Requirements

Functional requirements

The Royal Danish Air Force has requested your company to deliver a self protection suite for the F-16 combat aircraft. The required solution incorporates a pod and an intelligent cockpit control unit for controlling the EW suite. The pod will be dispensing payloads (chaffs and flares) and hosting the Missile Warning System (MWS). The solution shall provide warning upon detection of missile threats and be able to automatically dispense payloads in response. The MWS will be provided as Government Furnished Equipment (GFE) and be physically installed by your

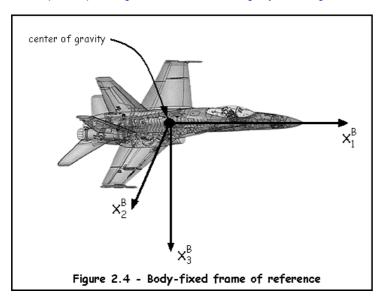
- KPI: The weapon system is not the aircraft. It's the weapons(bombs,missiles,rockets,guns,droptanks etc), the suspension/dispenser system, control & electrical system, monitoring(camera, IR detectors etc).
- Kaj: The increased weight will induce changed dynamic behavior of the aircraft (If the aircraft is thought of as the weapon system).
- Kaj: Dispensing payloads may limit the range of maneuvers executed by the airplane. Or the availability of directions to throw the payloads may have to be limited.
- Kaj: Dispensing payloads may limit on the range of used weapons. Or the availability of directions to throw the payloads may have to be limited.
- . Kaj: A standard magazine must be defined. Weight loaded and unloaded for calculating forces in the system
